License Amendment Request

**Callaway Unit No. 1
Renewed Facility Operating License NPF-30
NRC Docket No. 50-483**

**Revise Technical Specifications to Adopt Applicable Elements of
TSTF-439, Revision 2, "Eliminate Second Completion Times Limiting Time From
Discovery of Failure to Meet and LCO"**

Description and Assessment Specific to TSTF-439

Example 1

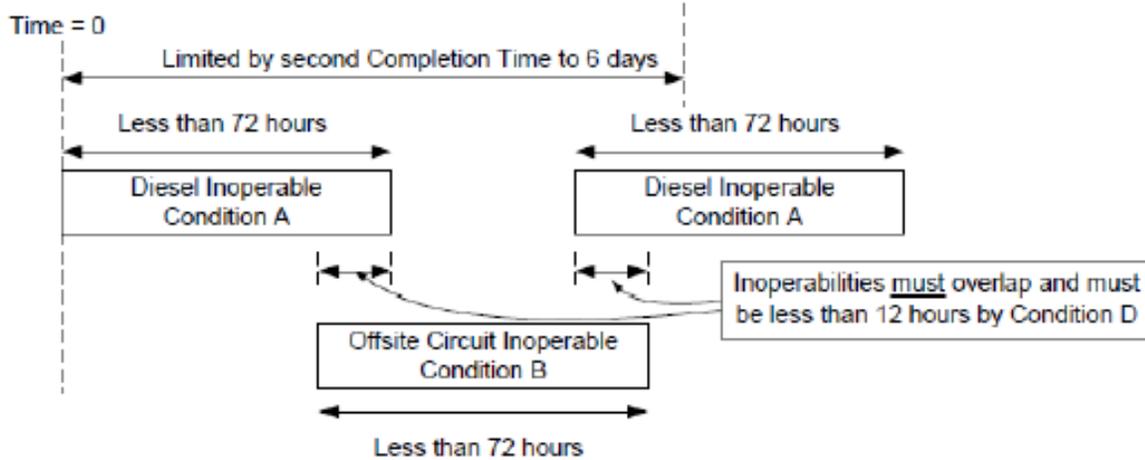
Specification 3.8.1, "AC Sources - Operating," has a 72-hour Completion Time for one offsite circuit inoperable (Condition A) and a 72-hour Completion Time for one diesel generator inoperable (Condition B). Both Condition A and Condition B have a second Completion Time of "6 days from discovery of failure to meet the LCO." The second Completion Time limits plant operation when Condition A or B is entered, and before the inoperable system is restored, the other Condition is entered, and then the first inoperable system is restored, and before the remaining inoperable system is restored, the other Condition is entered again. This highly improbable scenario is further limited by Condition D which applies when an offsite circuit and a DG are inoperable. It limits plant operation in this Condition to 12 hours. See Example 1 for an illustration.

As stated above, the Reactor Oversight Process monitors the availability of mitigating systems, including the emergency AC sources (DG unavailability). Such frequent, repeated failures of the AC sources would be reported to the NRC and this represents a strong disincentive to such operation.

Example 2

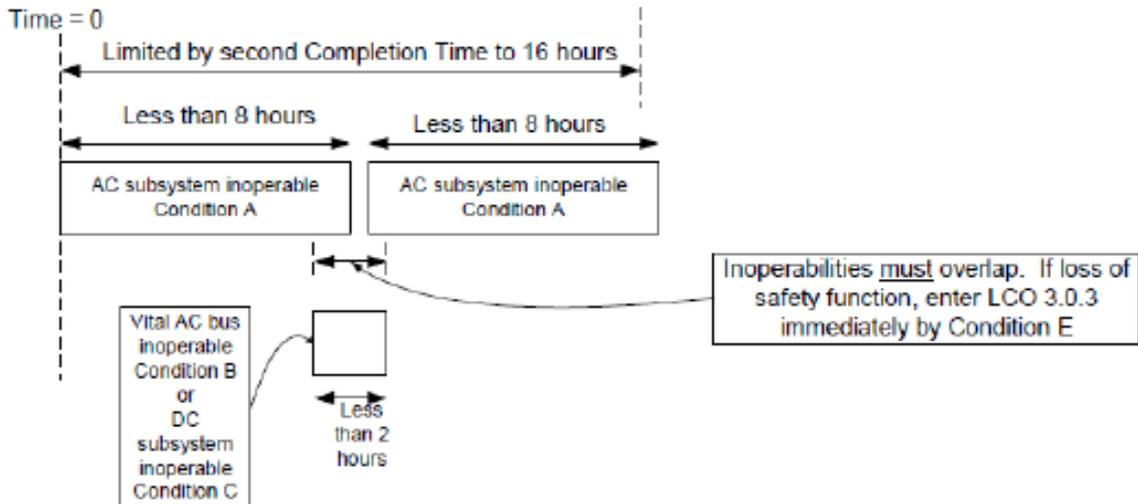
Specification 3.8.9, "Distribution Systems - Operating," has an 8-hour Completion Time for one or more AC electrical power distribution subsystems inoperable (Condition A), and a 2-hour Completion Time for one or more AC vital buses (Condition B) or one or more DC electrical power subsystems (Condition C) inoperable. Conditions A, B, and C have a second Completion Time of 16 hours from discovery of failure to meet the LCO. Condition E applies if two or more electrical distribution subsystems are inoperable and, if it results in a loss of safety function, LCO 3.0.3 must be entered immediately. See Example 2.

The second Completion Time is not needed. First, it is unusual for an AC electrical power subsystem or AC vital bus to be inoperable without causing a reactor trip. Secondly, Completion Times are very short (8 and 2 hours), providing little time to restore systems such that the Conditions overlap and multiple inoperabilities occur. Lastly, should any overlapping inoperabilities that result in a loss of safety function occur, a plant shutdown in accordance with LCO 3.0.3 is required.

Example 3

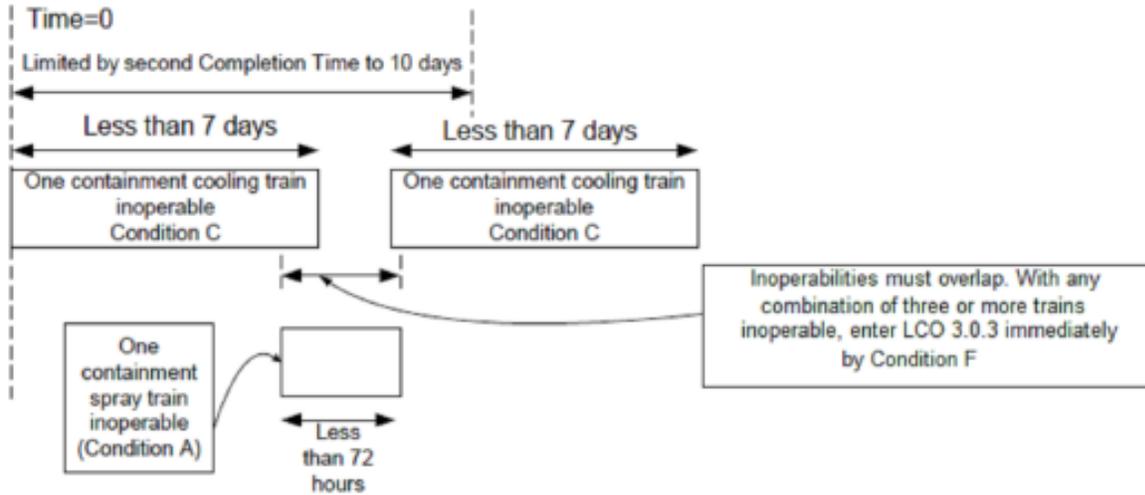
Specification 3.6.6A, "Containment Spray and Cooling Systems (Credit taken for iodine removal)," has a 72-hour Completion Time for one containment spray train inoperable (Condition A) and a 7-day Completion Time for one containment cooling train inoperable (Condition B). Conditions A and B have a second Completion Time of 10 days from discovery of failure to meet the LCO. Condition F also states that if two containment spray trains are inoperable or any combination of three or more trains are inoperable, LCO 3.0.3 must be entered immediately. Specification 3.6.6B, "Containment Spray and Cooling Systems (Credit not taken for iodine removal)," has a 7-day Completion Time for one containment spray train inoperable (Condition A) and a 7-day Completion Time for one containment cooling train inoperable (Condition B). Conditions A and B have a second Completion Time of 14 days from discovery of failure to meet the LCO. Condition G also states that if any combination of three or more trains are inoperable, LCO 3.0.3 must be entered immediately. See Example 3 for an illustration of Specification 3.6.6A.

The second Completion Time is not needed. Any combination of two of the four trains can perform the safety function. Adverse combinations require entry into LCO 3.0.3. The second Completion Time restricts operation with only one train inoperable, but that is unnecessary because when one train is inoperable, there are still three operable trains and only two trains are needed to perform the safety function. Therefore, the second Completion Time is overly restrictive.

Example 4

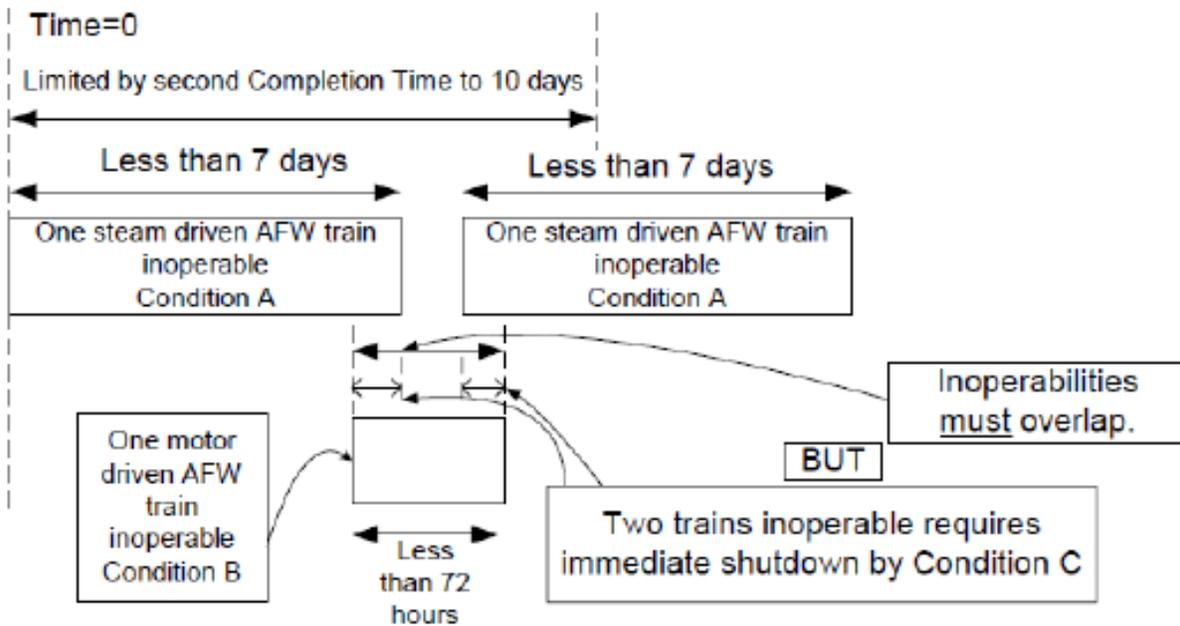
Specification 3.7.5, "Auxiliary Feedwater System (NUREG-1430 - Emergency Feedwater System)," has a 7-day Completion Time for one inoperable steam supply to a turbine driven AFW pump (rendering the turbine driven AFW pump inoperable) (Condition A) and a 72-hour Completion Time for one AFW train inoperable (Condition B). Conditions A and B have a second Completion Time of 10 days from discovery of failure to meet the LCO. In order for the second Completion Time to be limiting, entry into and out of Conditions A and B must occur, which requires the turbine driven and motor driven AFW pumps to be concurrently inoperable. However, Condition C states that if AFW trains are inoperable the plant must be in MODE 3 in 6 hours and MODE 4 in 18 hours. See Example 4.

The second Completion Time is not needed. For the second Completion Time to be limiting, Conditions A and B must be entered concurrently. However, Condition C requires an immediate shutdown when two trains are inoperable. Therefore, the second Completion Time will never be limiting and can be removed. In addition, the Reactor Oversight Process monitors the availability of the AFW system. Such frequent, repeated failures of the AFW system would be reported to the NRC and this represents a strong disincentive to such operation.
